Change Order

Change Order No.: 18 CBCL Project No. 241016.00
Date: January 27, 2026
To: Alex Sawyer – Harbour Construction
Contract Name: Mahone Bay Edgewater Street Improvements
Contract No.: 241016.00
Refer To: Harbour Quotation Document & SI-08
Copies To: Dylan Heide (Town of Mahone Bay)

Project Name:	Town of Mahone Bay Edgewater Street Improvements	Project No.:	241016.00
Contract:	Contract No. 241016.00	Contract No.:	241016.00
SI No.:	08	Date:	August 25, 2025
Refer To:	IFC- Rev 1 Drawings dated April 1, 2025		
Copies To	Alex Sawyer (Harbour Construction); Dylan Heide (Town of Mahone Bay)

Date AUG 21/2025	Scale AS NOTED	Designed MF	Drawn MF/DS	Checked AB	Approved AB	CBCL No. 241016.00	Contract -
		EDGEWATER STREET IMPROVEMENTS					Drawing ESK02
		STREET LIGHTING REVISION

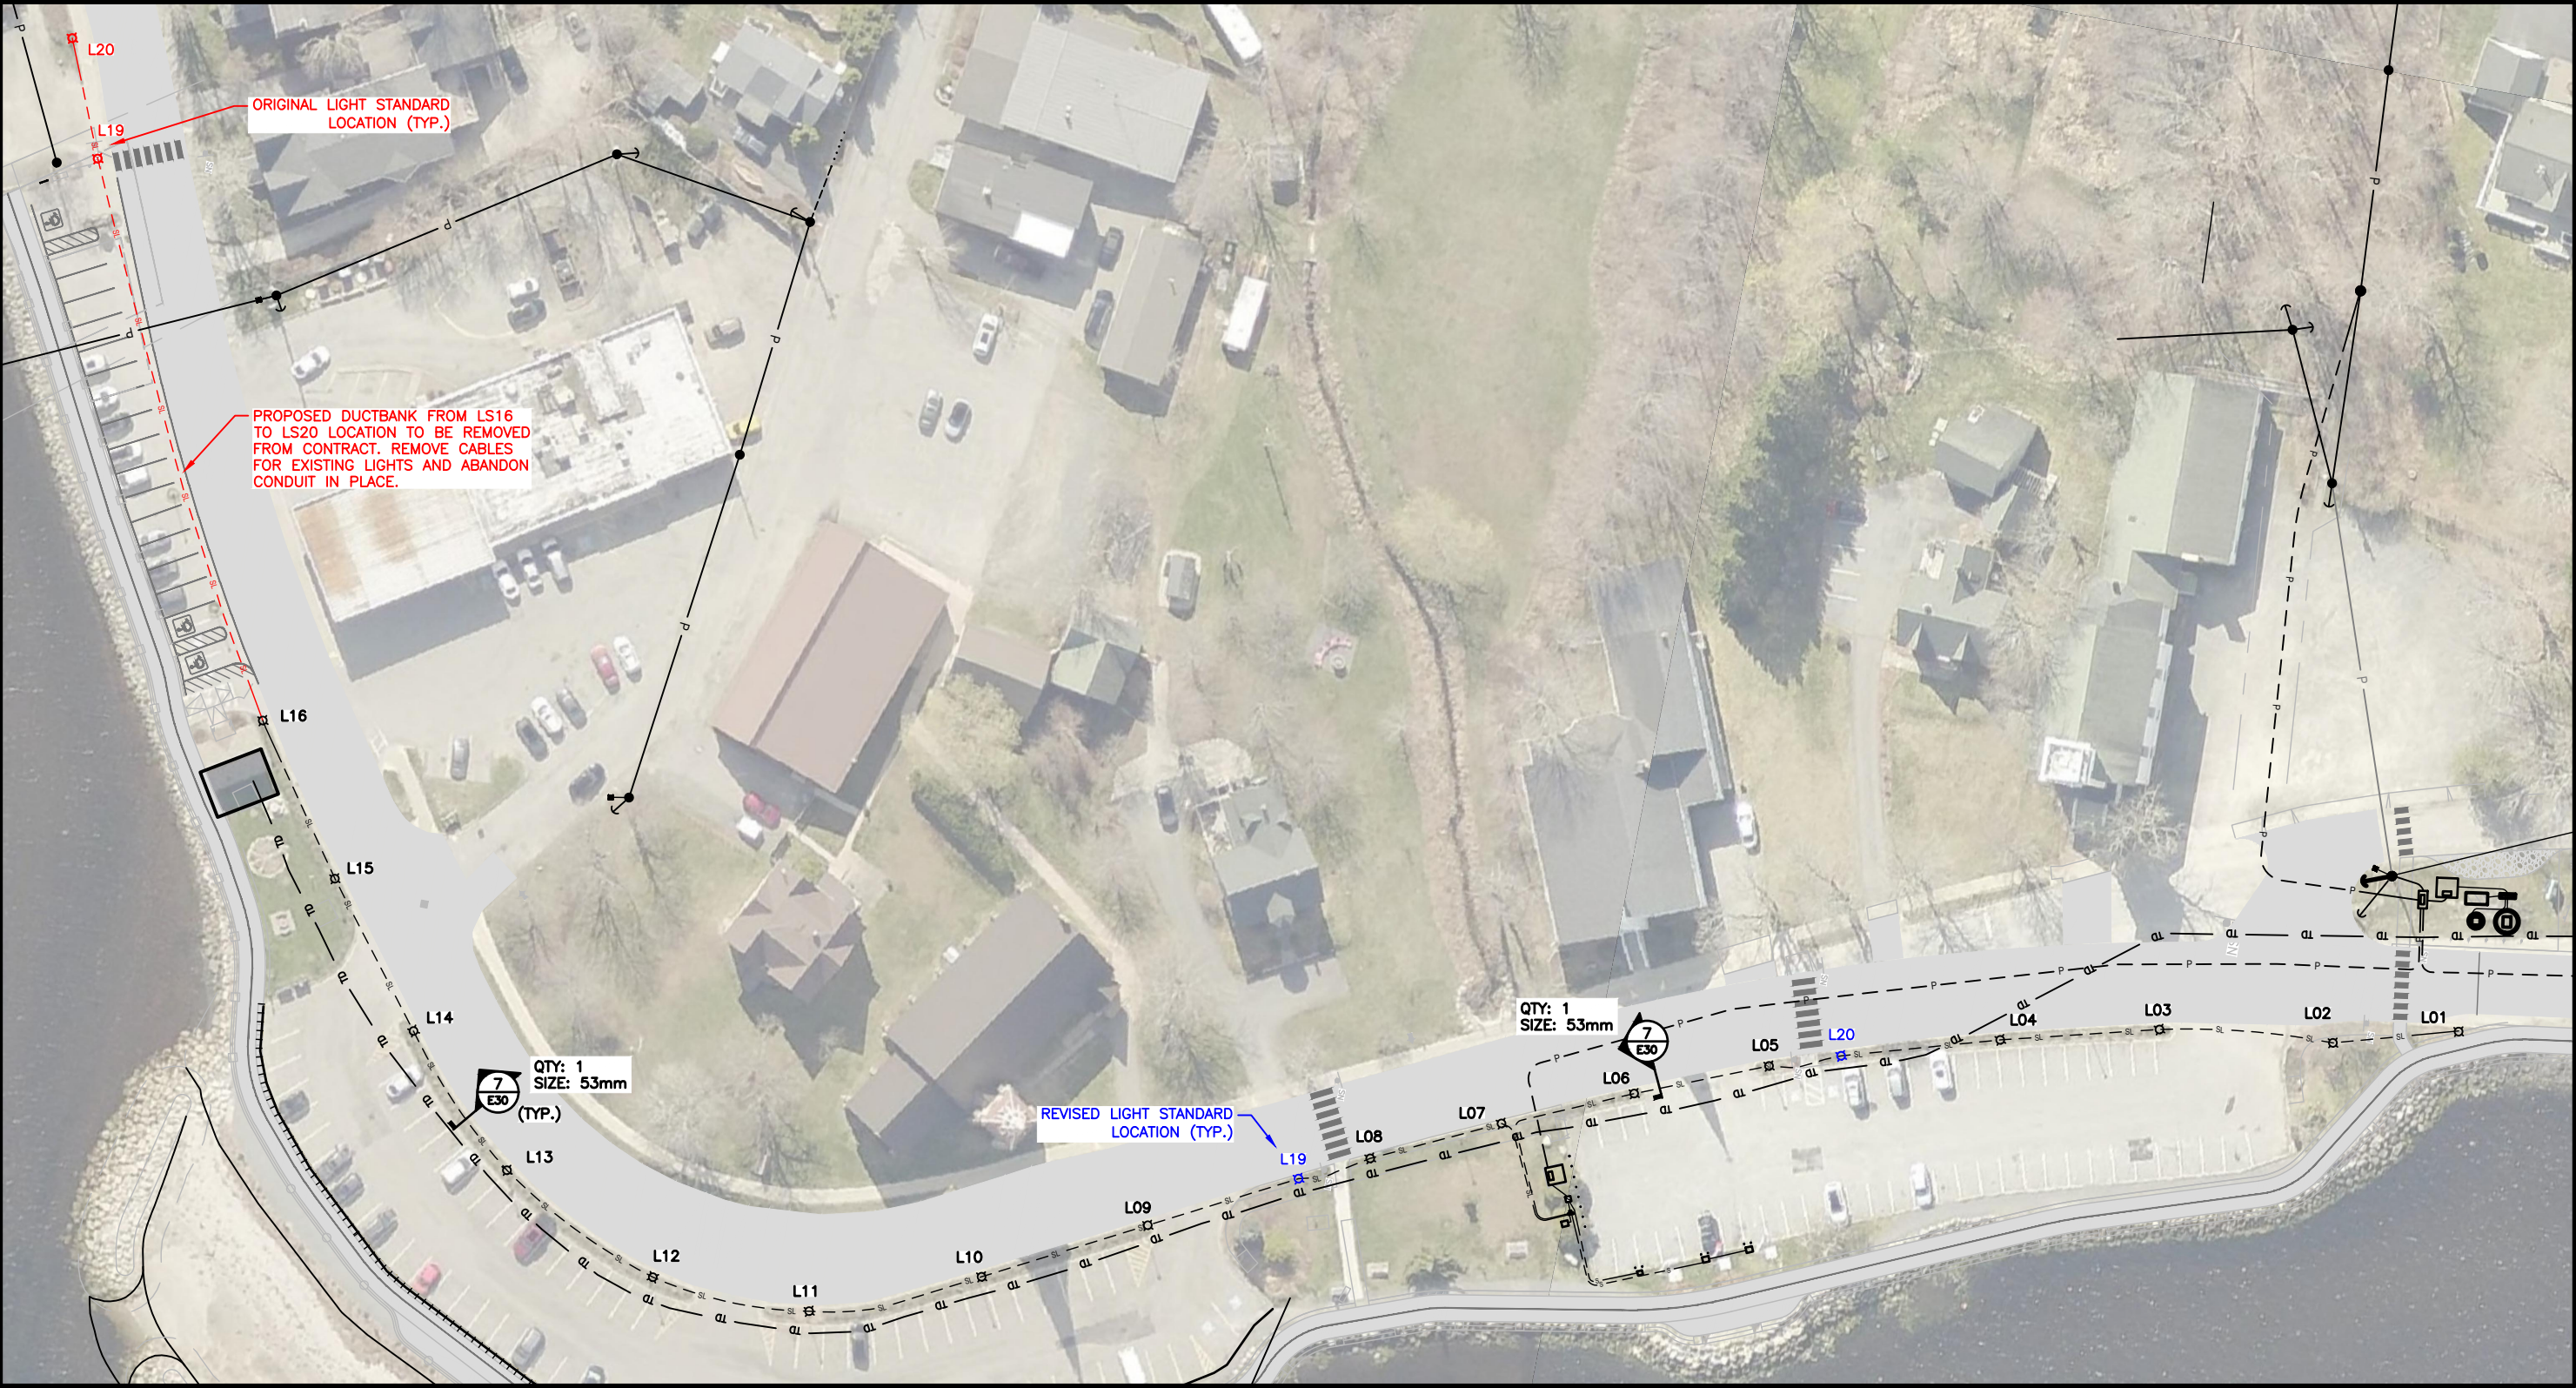
The following adjustments to the street lighting installation are to be completed, refer to Sketch **ESK02** attached:

1. Replacement of specified 80W light fixtures on 22ft poles with 40W Holophane fixtures on 14ft poles, per the attached product sheets.
2. Revise the locations of LS19 and LS20 to crosswalk locations (including minor shifts of other light standards) per the attached ESK02.
3. Removal of 80m of proposed 1-53mm direct buried ducts per Section 7 on Sheet E30 (Ductbank to stop at LS16 per attached ESK02), adjusting total contract quantity from 370m to 290m.
4. Reduce wire sizing noted on E20 for south lighting circuit to match the north circuit (2 - #6 AWG + 1 - #8 AWG BOND).

Date AUG 21/25	Scale AS NOTED	Designed MF	Drawn MF	Checked LO'K/AB	Approved -	CBCL No. 241016.00	Contract -
		EDGEWATER STREET IMPROVEMENTS					Drawing ESK03
		UNITED CHURCH - MAHONE BAY ELECTRICAL ARRANGEMENT

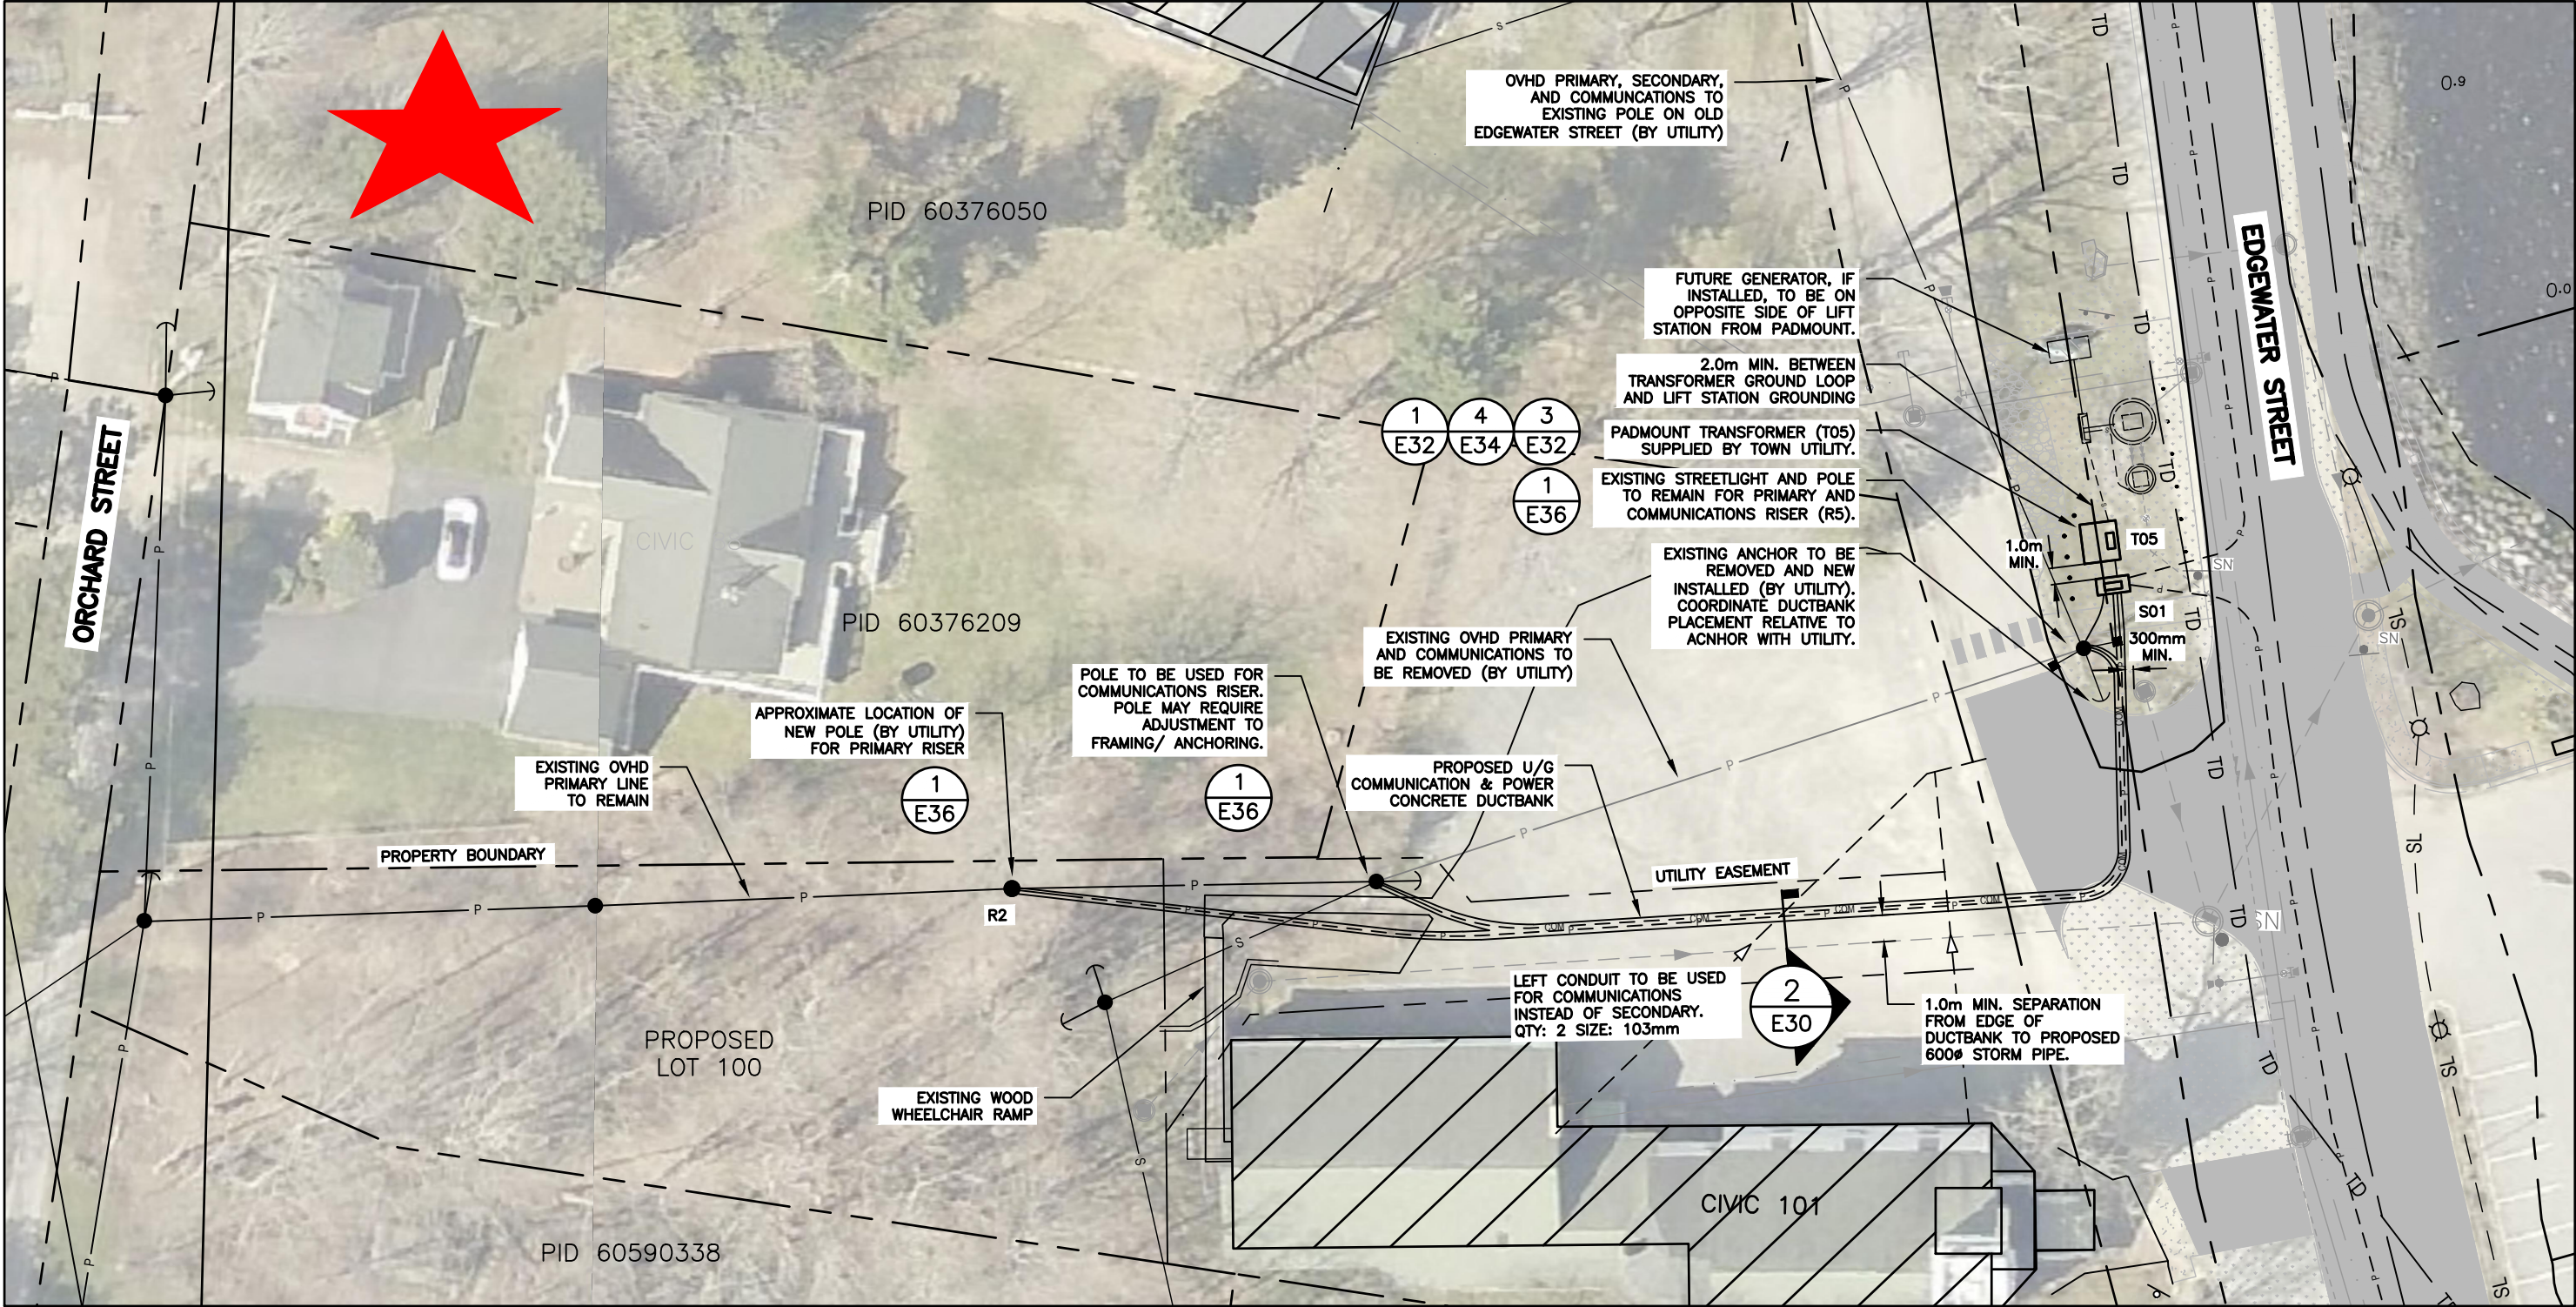
Changes to be made to the electrical / communications arrangement around the United Church parking lot and lift station LS04 per attached sketch **ESK03** and IFC Rev 2 drawing **E20**.

- Revise R2 riser pole location. Add communications riser to existing pole.
- Revise ductbank to median/LS04 area to include communications in the ductbank.
- Revise pole and ductbank layout along Old Edgewater Street.
- Replace overhead transformer service to LS04 with service from padmount transformer (supplied by Town Utility).

Date AUG 22/2025	Scale AS NOTED	Designed MF	Drawn MF/DS	Checked LO'K/AB	Approved AB	CBCL No. 241016.00	Contract -
		EDGEWATER STREET IMPROVEMENTS					Drawing ESK05
		CIVIC #205 EQUIPMENT REVISION

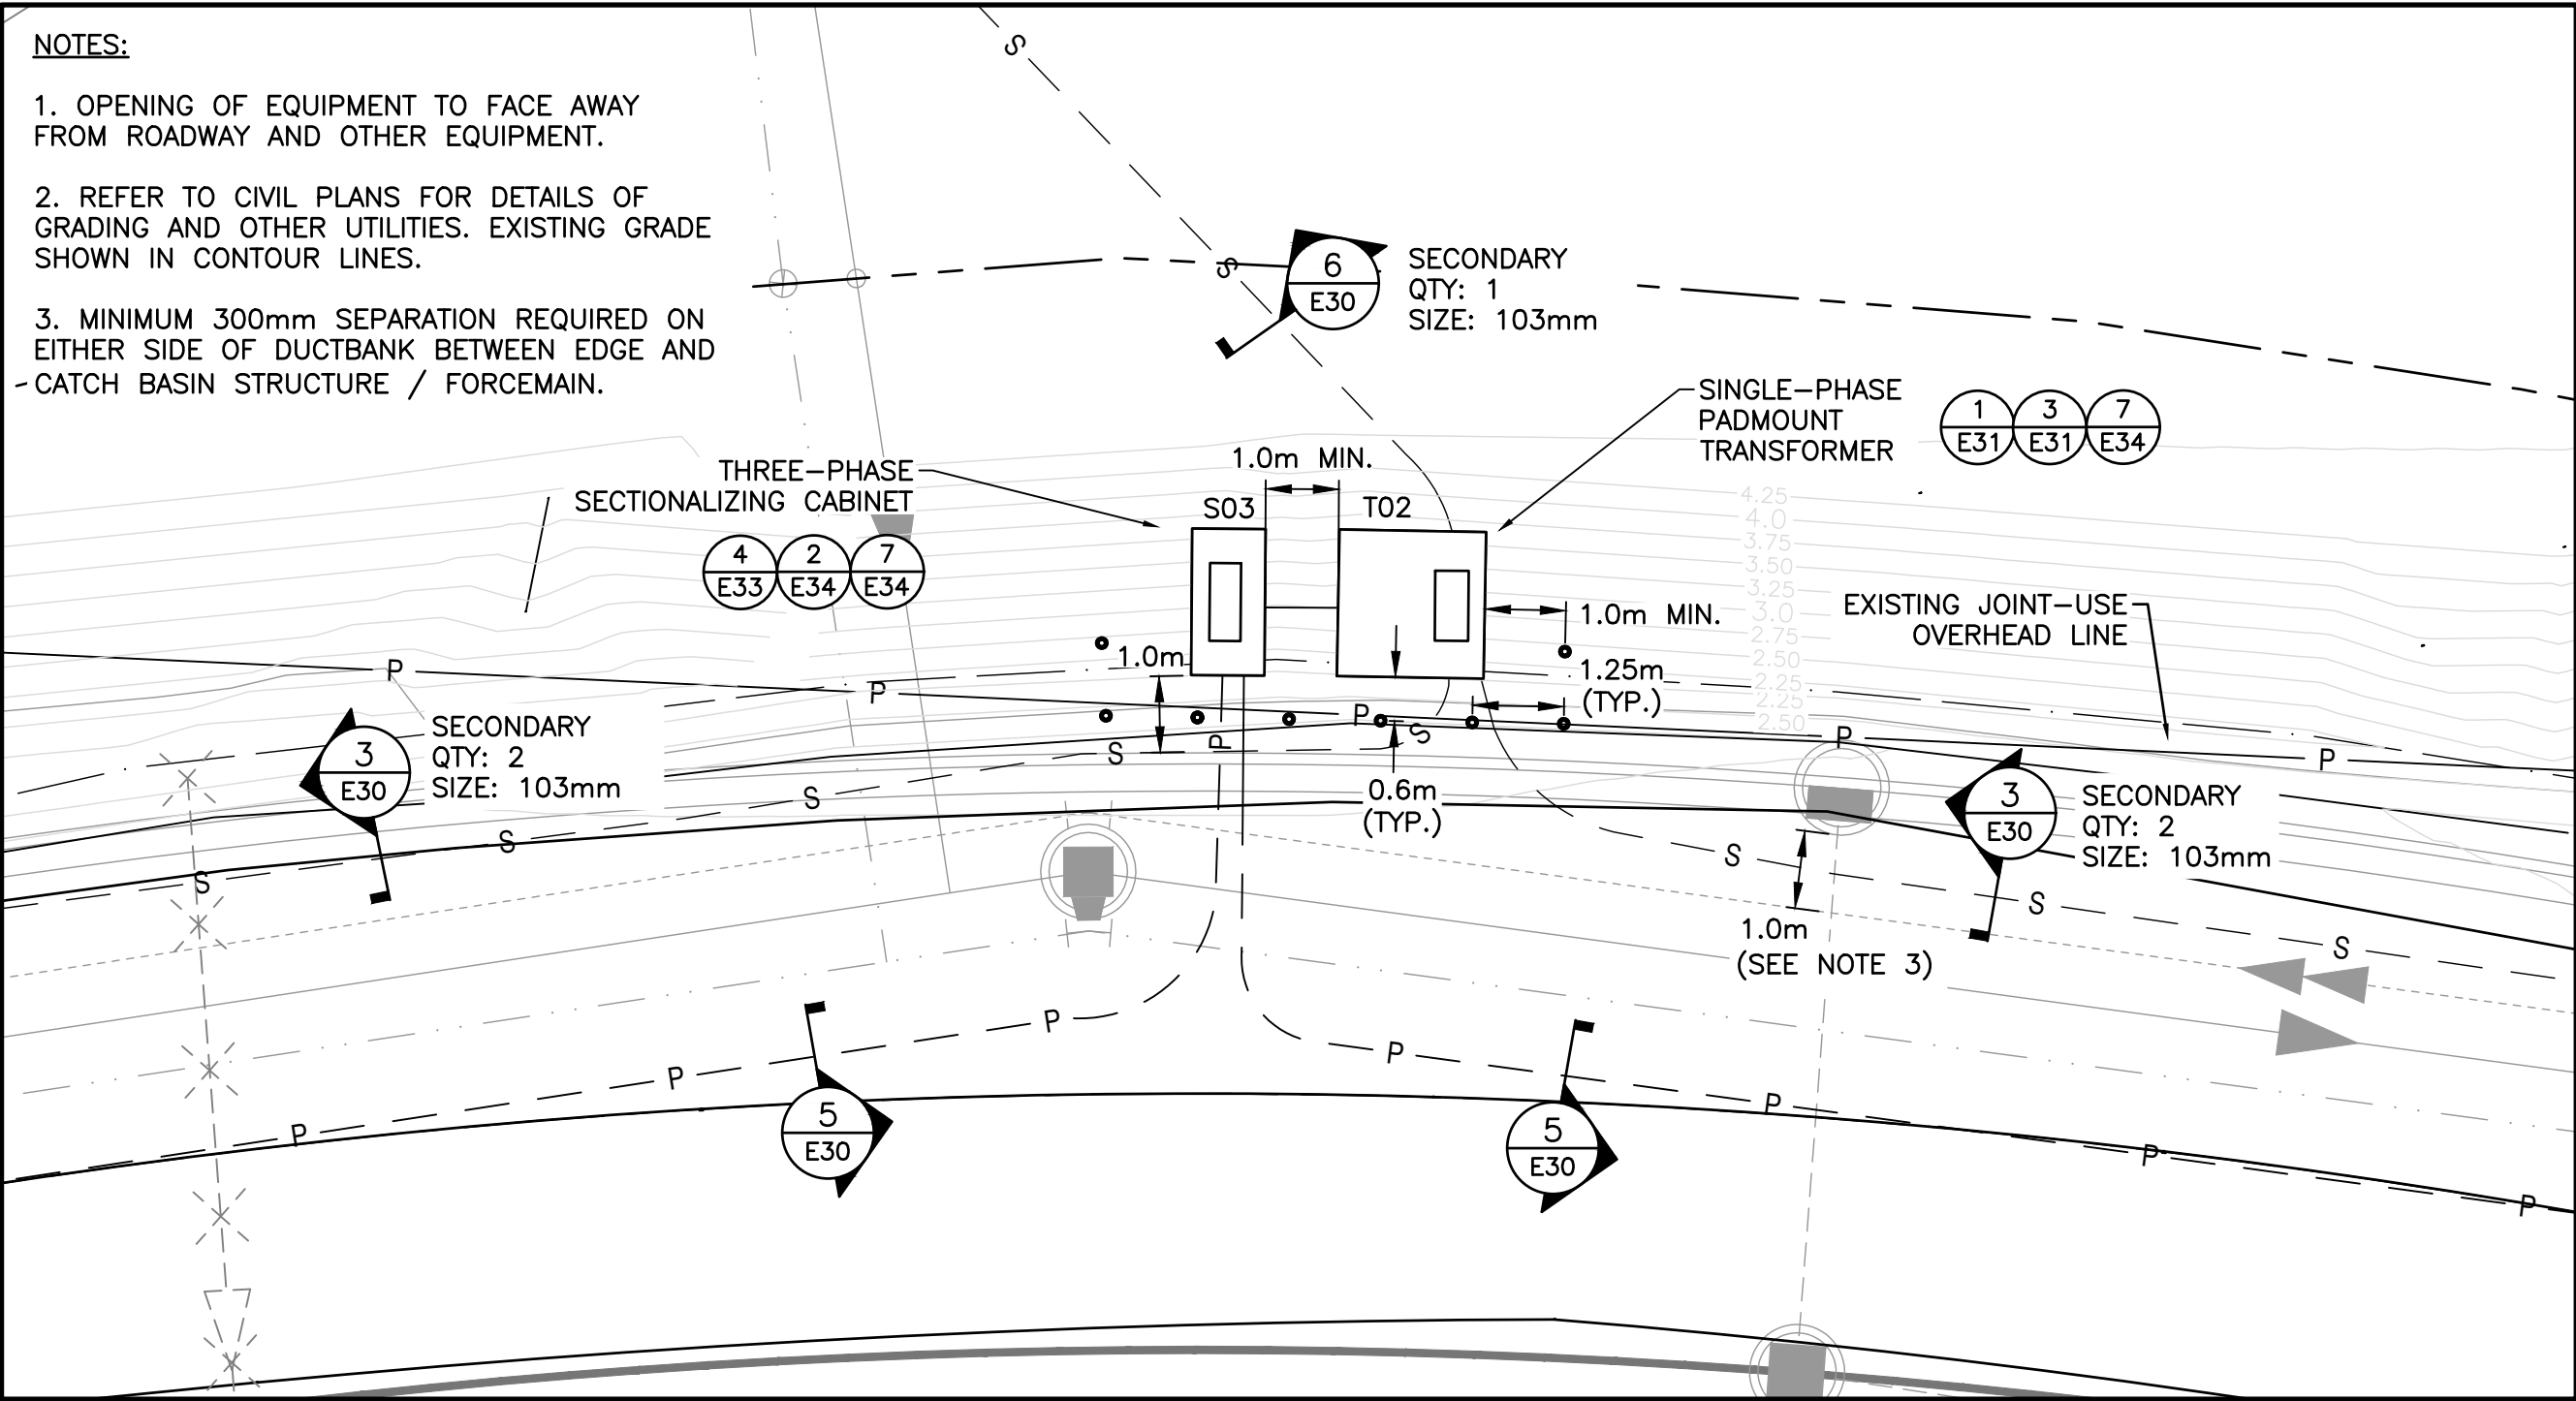
Revise electrical equipment arrangement in front of civic #205 per attached sketch **ESK05**.
